UNITED STATES PATENT AND TRADEMARK OFFICE

Office Action Summary	Application No.	Applicant(s)	
	10/515,980	WATANABE ET AL.	
	Examiner	Art Unit	
	James Pilkington	3682

DETAILED ACTION

Taken from Strasburg Figure 1

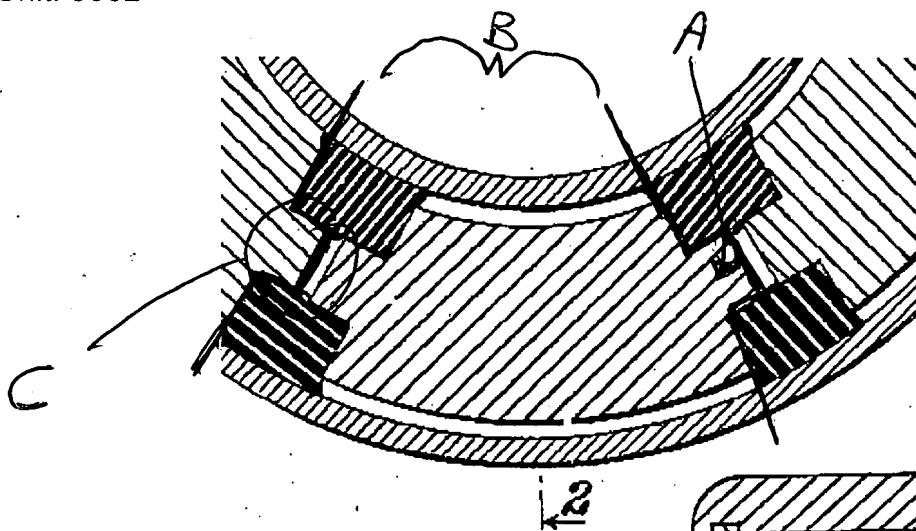
Re clm 3, Strasburg discloses that the connecting means of each ring piece includes a protruding piece (A, see Figure below) formed in one end of the ring piece (B, combination of 10 and 11) and a hole formed in the other end (C) of the ring piece (B), and said ring pieces are bonded in a circumferential direction by close-fitting the protruding piece (A) of one of the ring pieces (B) adjacent in a circumferential direction into the hole of the other one of the adjacent ring pieces.
